1-15 and 2-12 Conferta Avenue Rouse Hill (Tallawong  
Station South)

## Section 4.55 Planning Statement (SSD 9063)

Modification to approved Concept Plan for a mixed use development comprising residential apartments, commercial uses, public domain works and landscaping including a public park

**May 2020**

Site plans with  
site labels

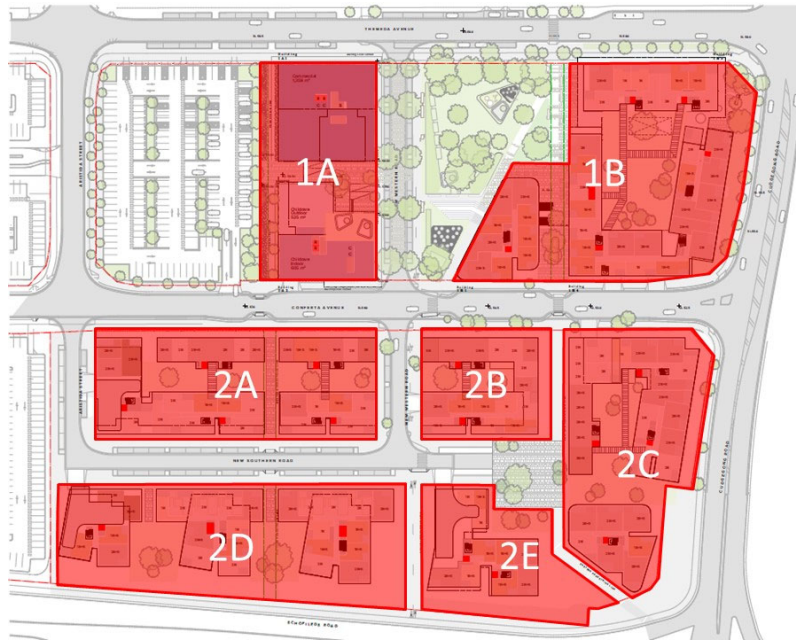
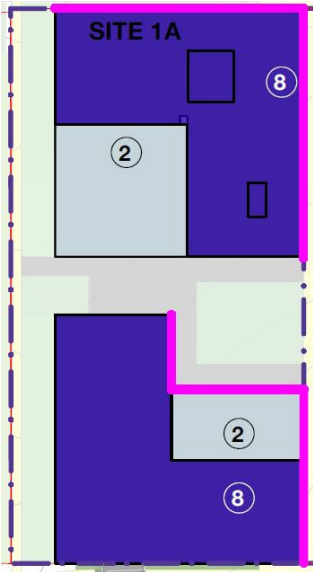
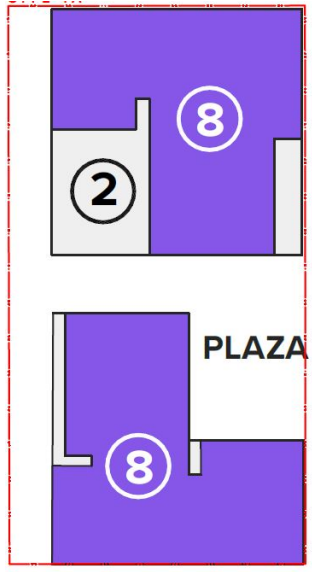
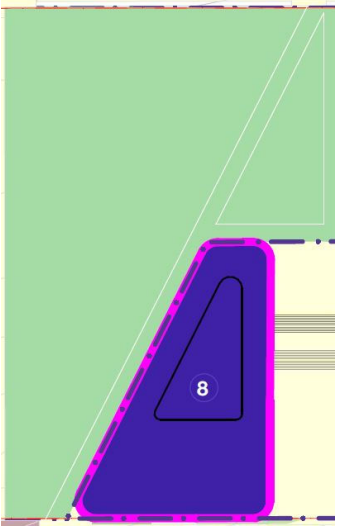
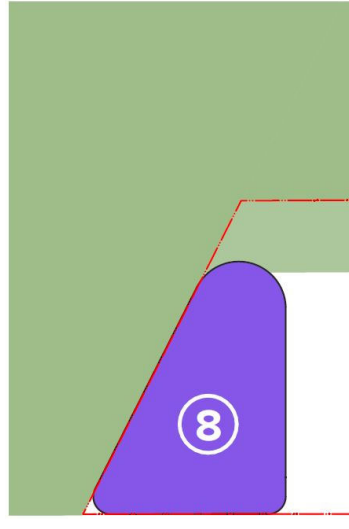
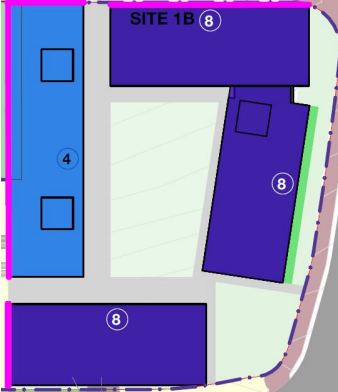
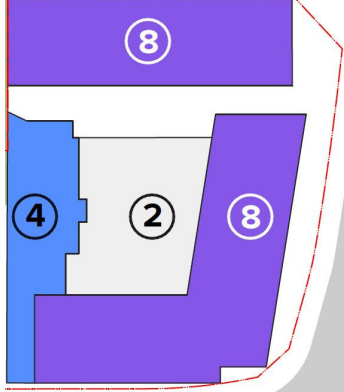
Site	Approved	Modified
<p>1A</p> <ul style="list-style-type: none"> <li>Shift the built form to maximise solar access to the plaza and building façade</li> <li>Step the built form down to the park and commuter car park to provide opportunities for extended outdoor areas above</li> </ul>		
<p>1B (Park)</p> <ul style="list-style-type: none"> <li>Reduce building footprint to object building to provide a direct visual and physical connection to the pedestrian boulevard from the commuter car park, increasing the size of the park</li> </ul>		
<p>1B Retail</p> <ul style="list-style-type: none"> <li>Shift building forms to respond to new through site link</li> <li>Reconfigure the built form to define the corner of Cudgegong Road and Conferta Ave, creating a gateway to the residential precinct</li> </ul>

Site	Approved	Modified
<p>2C</p> <ul style="list-style-type: none"> <li>• Redistribute built form to maximise solar access to plaza</li> <li>• Reduce building lengths to increase visual and physical permeability through the site</li> <li>• Redistribute heights to provide a lower scale building interface along the length of the pedestrian boulevard</li> </ul>		
<p>2D</p> <ul style="list-style-type: none"> <li>• Rotate buildings to orientate outlook north in response to solar access site building alignments</li> <li>• Reduce upper building widths to Schofields Road and remove step on southern façade.</li> </ul>

Proposed amendments to Concept Plan building envelopes

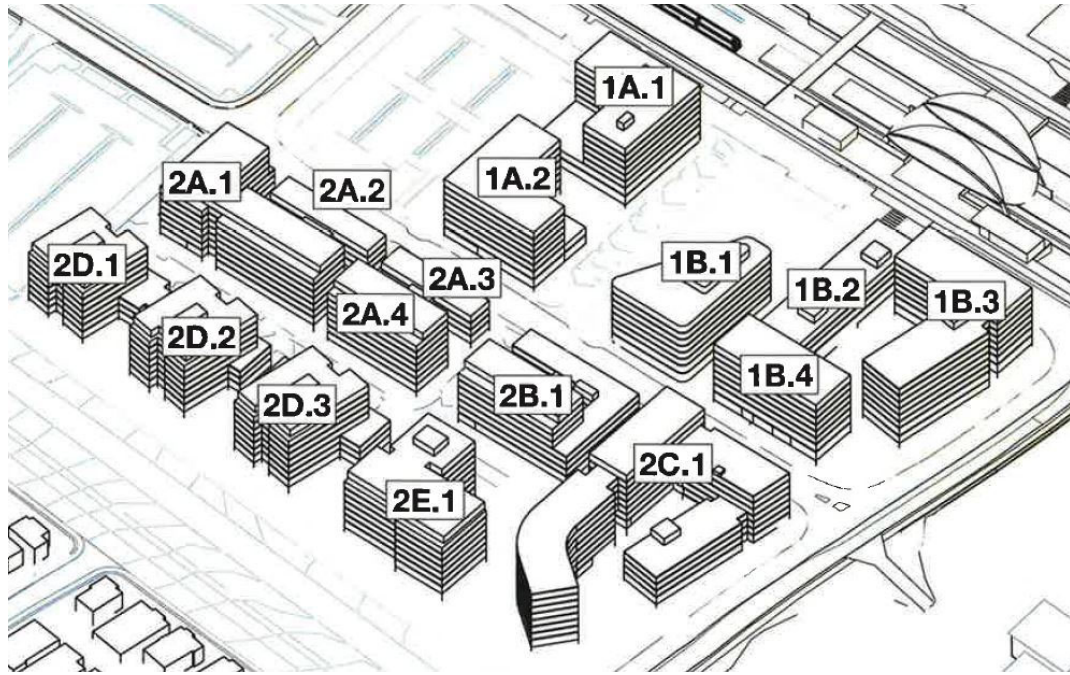
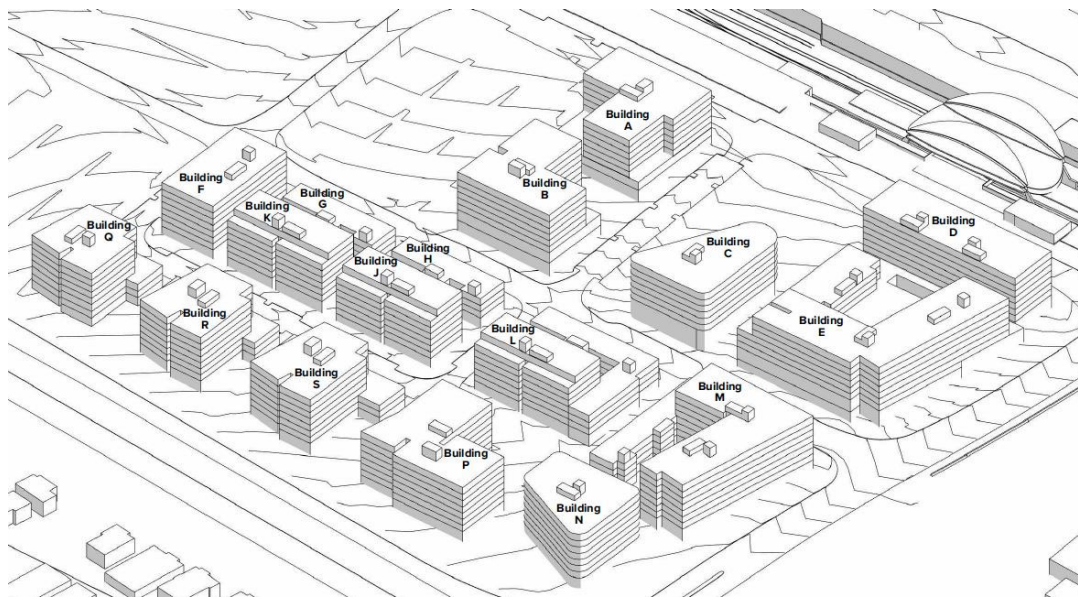
A massing comparison of the approved building envelopes and proposed amendments to the building envelopes is illustrated in Figures 7 and 8 below:

Proposed  
storeys for  
amended  
Concept  
Plan

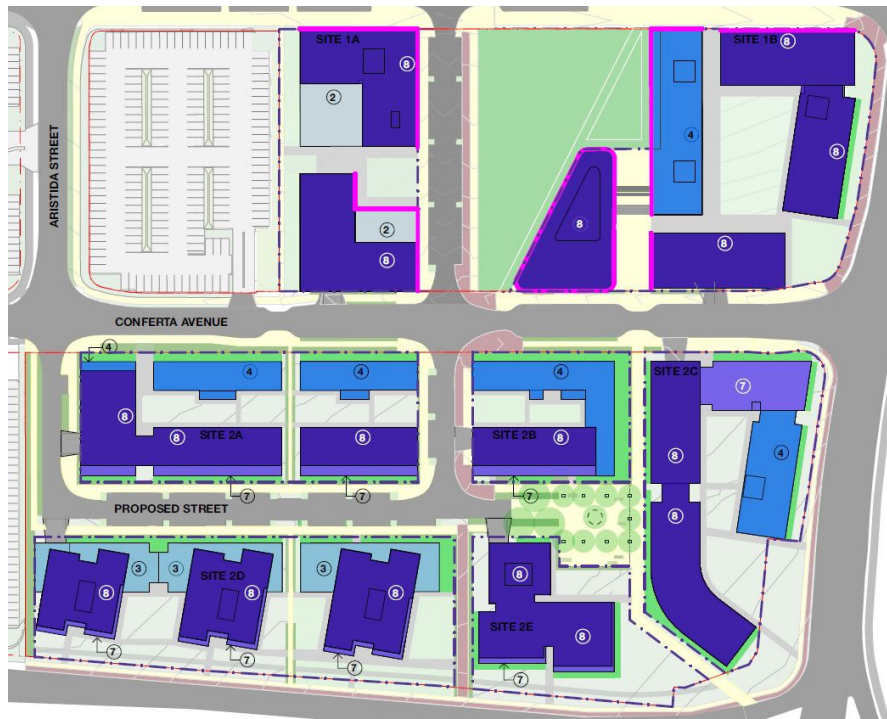
Notwithstanding the increase to the heights for some buildings, most of the parapets in Site 2 are actually lower than the approved parapet heights in the Concept Plan. Furthermore, the proposed height variations do not result in any change to the approved number of storeys.

Proposed amendment to Concept Plan with 26 metre height plane

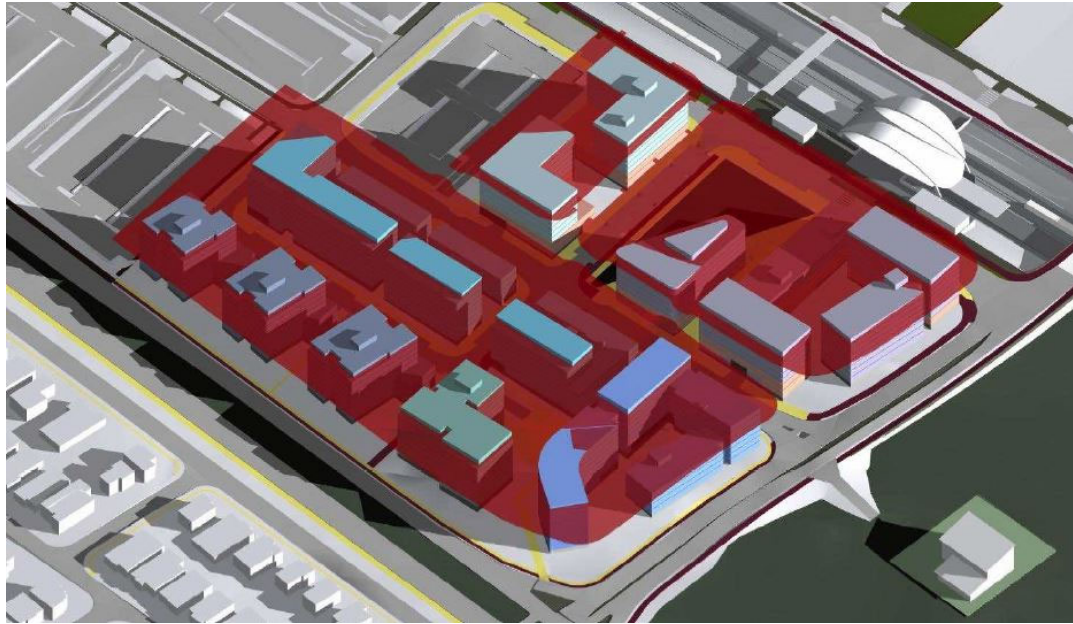
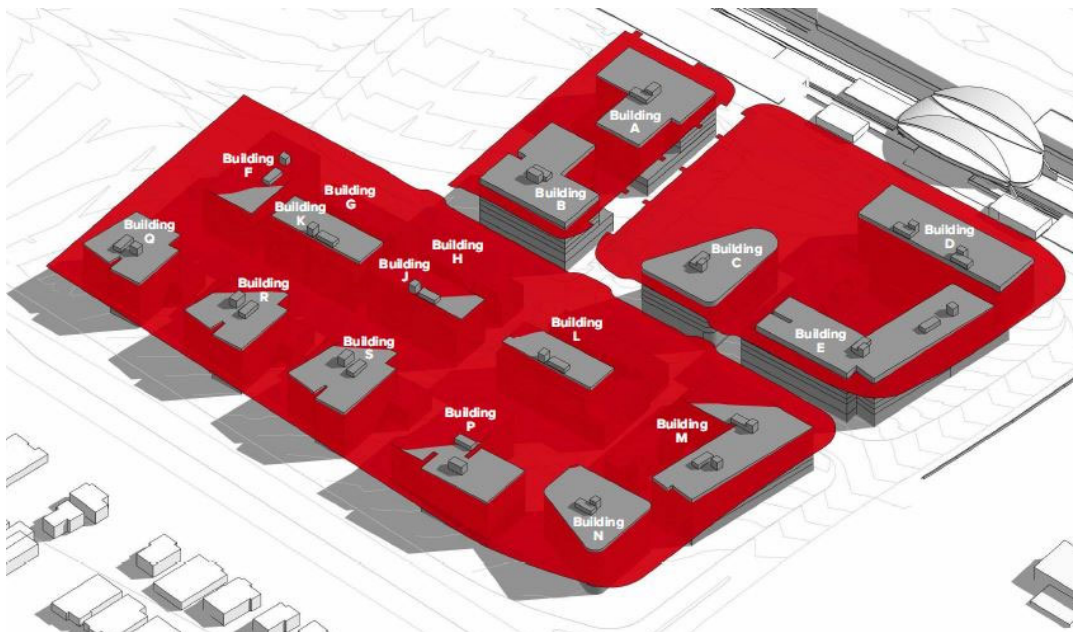
Notwithstanding the above, as part of the preparation of this detailed development application, an analysis of the approved heights of the building envelopes by Turner Architects has identified that the heights of some of the buildings need to increase further for the following three reasons:

- Insufficient height was provided for the ground floor of the retail component with only 4 metre floor to ceiling heights instead of 6 metre;
- Lift overruns were not provided for many buildings; and
- Refinement of ground floor levels of various buildings to properly deal with the significant cross falls across the site and achieving appropriate accessibility grades as well as relationships between ground floor levels and the surrounding public domain.

Accordingly, it is proposed to amend the approved heights with minor to moderate changes across the Concept Plan.

Building Ref (Turner/ Concept)	Proposed Max height	Proposed Variation to 26m height control	Concept approval Max height	Concept approval variation to 26m height control	Increase/ Decrease compared to Concept Plan
A/1A.1	<ul style="list-style-type: none"> <li>Parapet - 28.49m</li> <li>Lift overrun - 32.36m</li> </ul>	<ul style="list-style-type: none"> <li>Parapet - 2.49m (9.57%)</li> <li>Lift overrun - 6.36m (24.4%)</li> </ul>	<ul style="list-style-type: none"> <li>Parapet - 28.4m</li> <li>Lift overrun - 31.5m</li> </ul>	<ul style="list-style-type: none"> <li>Parapet - 2.4m (9.23%)</li> <li>Lift overrun - 5.5m (21.1%)</li> </ul>	<ul style="list-style-type: none"> <li>Parapet +0.09m</li> <li>Lift overrun +0.86m</li> </ul>
B/1A.2	<ul style="list-style-type: none"> <li>Parapet - 29.15m</li> <li>Lift overrun - 32.98m</li> </ul>	<ul style="list-style-type: none"> <li>Parapet - 3.15m (12.11%)</li> <li>Lift overrun - 6.98m (26.8%)</li> </ul>	<ul style="list-style-type: none"> <li>Parapet - 28.4m</li> <li>No Lift overrun</li> </ul>	<ul style="list-style-type: none"> <li>Parapet - 2.4 metres (9.2%)</li> <li>No lift overrun</li> </ul>	<ul style="list-style-type: none"> <li>Parapet +0.75m</li> <li>No previous lift overrun +4.58m</li> </ul>

Proposed amendments to floor to ceiling height and lift overruns

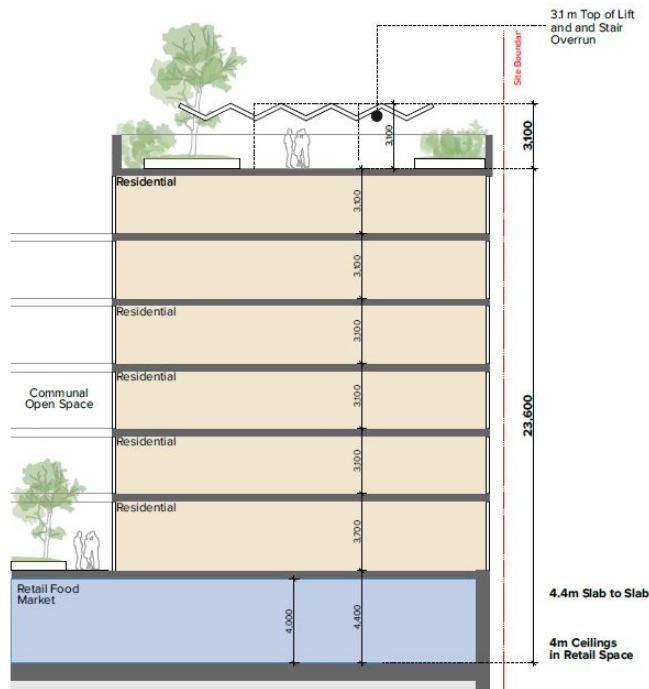
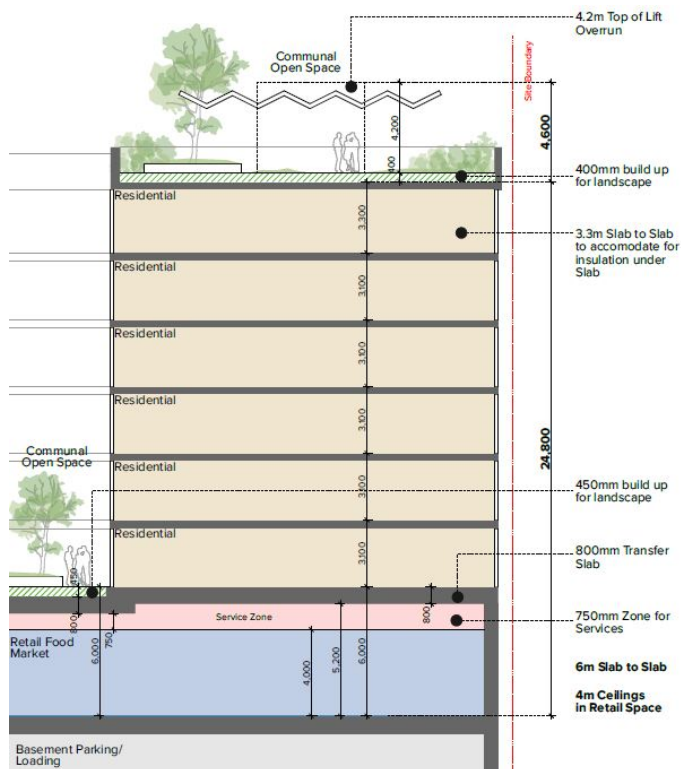
The approved Concept Plan provided 4 metres ceiling height, but only provided 4.4 metres floor to floor height. In order to accommodate adequate services zones and transfer depths, a floor to floor height of 6 metres is required to achieve a 4 metre ceiling height.

In relation to lift overruns, it is noted that many buildings in the Concept Plan were not nominated with any lift overruns at all. This has two consequences, the first being that it is not possible to access the roof top for common open space, and the second being that no lift overrun at all above the roof level means that the lift overrun needs to be accommodated within the same horizontal zone at the top floor which means that the lift terminates at the second top floor and all apartments on the top two floors can only be two storey apartments. In addition, where lift overruns were nominated they only had a 3.1 metre height whereas 4.2 metres is required as this is the average requirement of most lift manufacturers.

9am shadow  
on 21 June  
(red line  
indicates  
approved  
Concept Plan  
shadow)

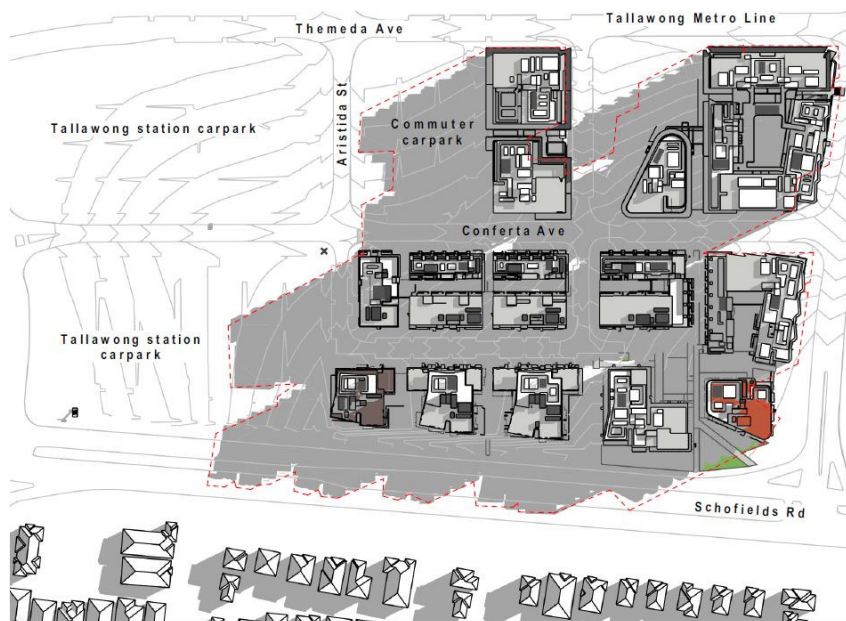
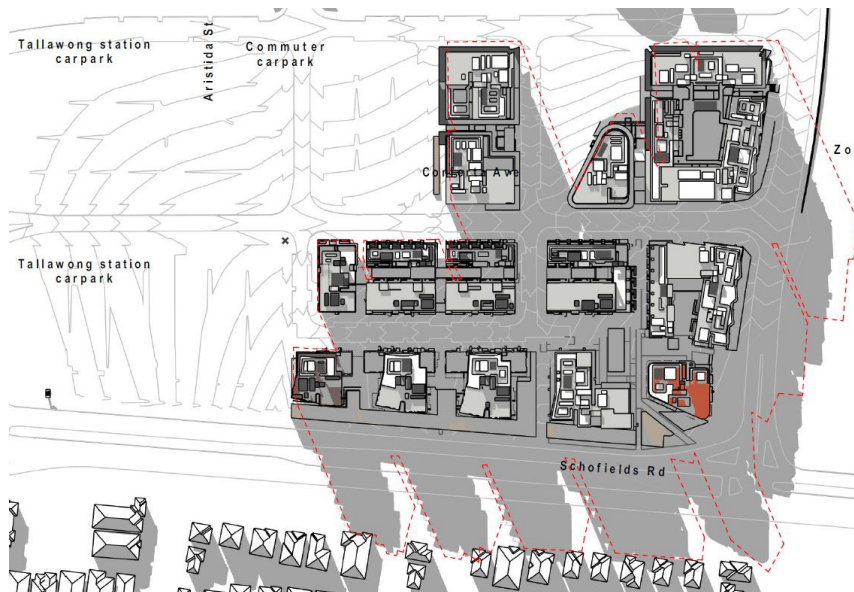
Whilst there are a range of increased height when compared to the Concept Plan which have resulted in changes to the shadow cast by the development when compared to the approved Concept Plan, as the parapets of all of the southern buildings have reduced there is actually a reduced shadow impact to the nearest sensitive properties at The Ponds across Schofields Road. This is illustrated in Figures 15, 16 and 17 below.

In relation to shadow impact to open space, whilst there is some increased shadow to the publicly accessible park, due to the location of the publicly accessible park at the northern end of the site it still enjoys extensive solar access and the majority of the park receives solar access from 10.30am to 3pm on 21 June.

Proposed  
amendments to  
street network  
and hierarchy

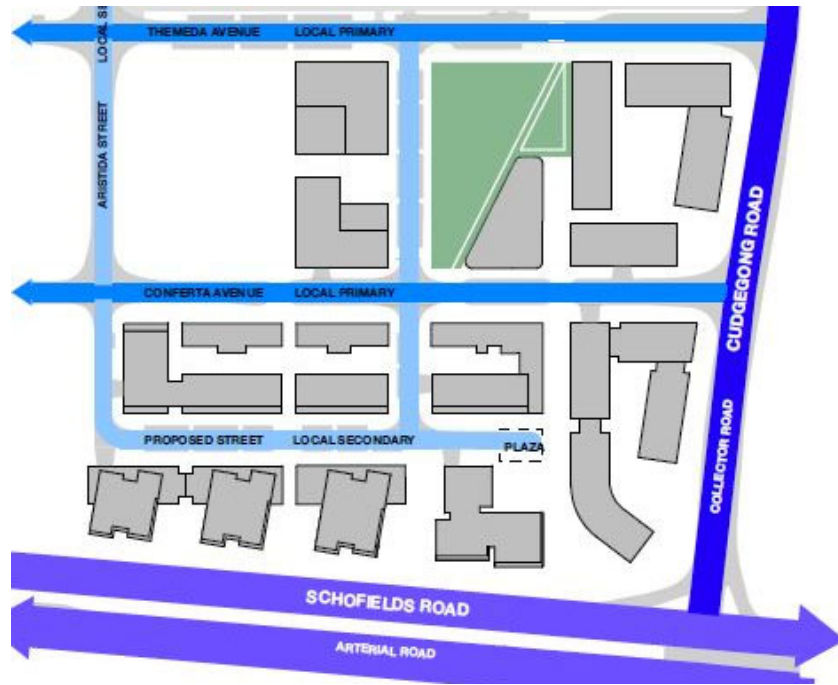
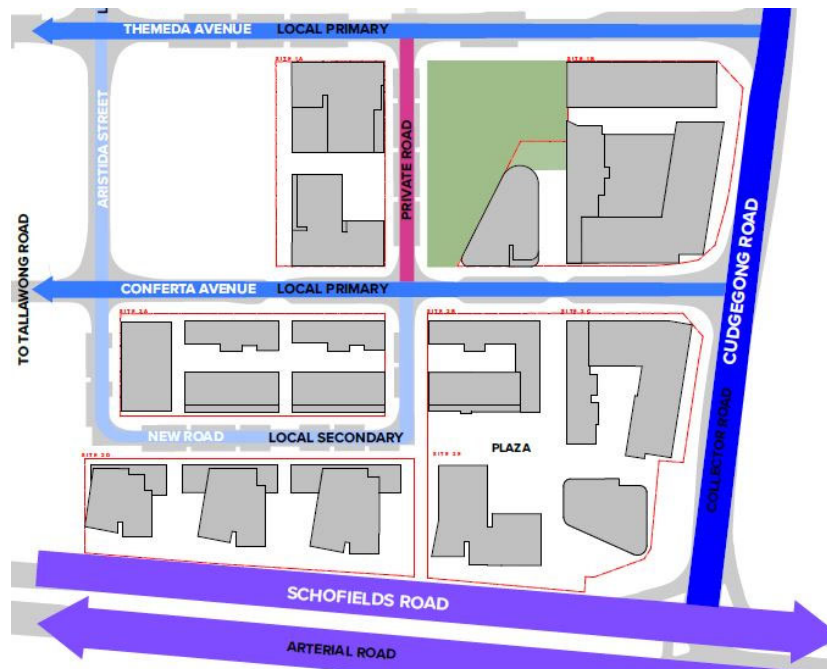
However, it is proposed that the park will be retained in private ownership and that public access of the park will be secured on title, as this provides more flexibility for the design of the park and a more intensive maintenance regime beyond that which would occur if the park was in public ownership. It also provides the opportunity to extend the basement below the park which achieves the following improvements:

- Consolidated entry and exit points to the basement for retail visitors and residents, providing clearer legibility and way-finding across the town centre;
- Increased active frontage to the street through reduced/dedicated carpark entry widths;
- Improved connectivity between the parking and the retail and commercial tenancies across Site 1;
- A less complicated retail visitor parking strategy consolidated across bigger plates on fewer levels;
- Clearer distinction/separation between retail and residential vehicular movements and parking areas;
- A reduction in the depth of excavation required across the site; and
- No reduction in amenity, quality or function of the park and public domain.

Proposed amendments  
to ownership plan

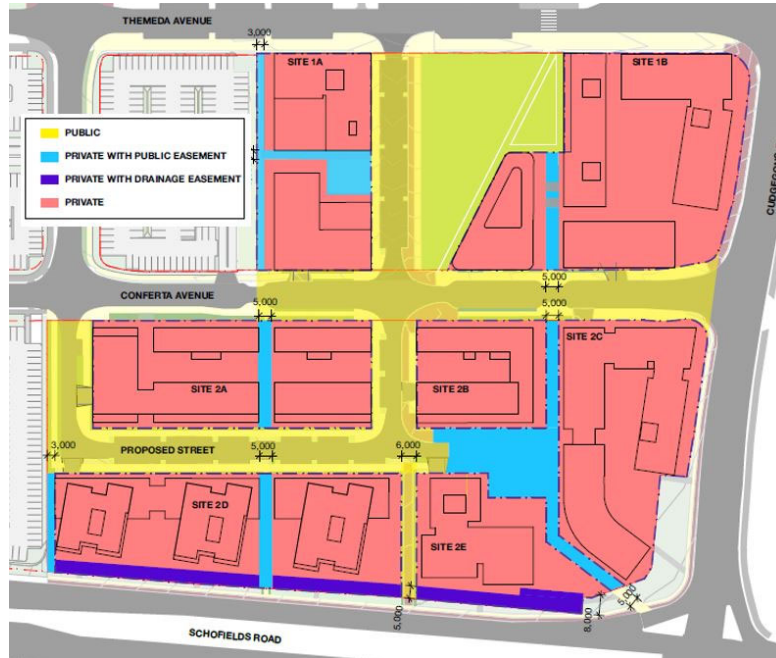
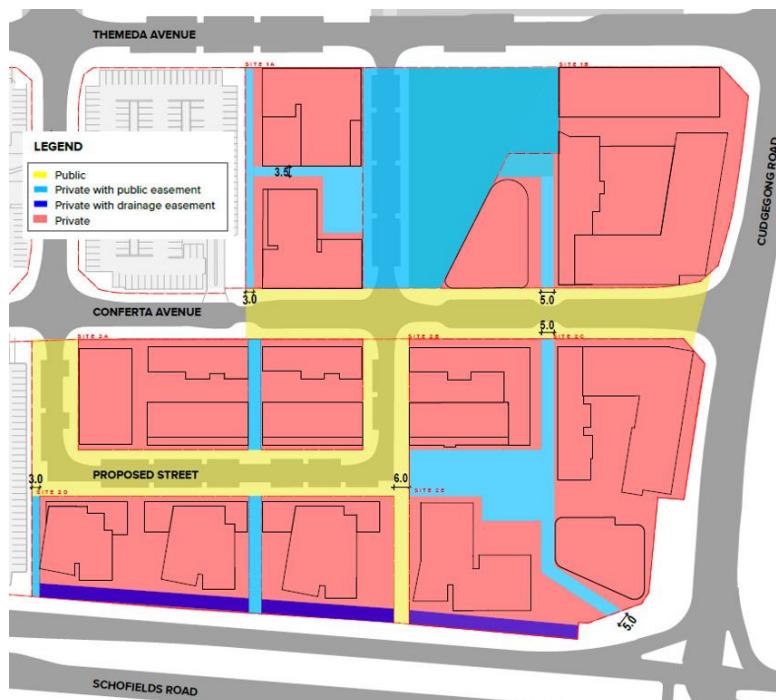
Having regard to the agreed changes to the design and also the ownership structure for the park and adjacent road, it is proposed to amend the approved 'ownership' diagram as illustrated in the Addendum Urban Design Report prepared by Turner architects.
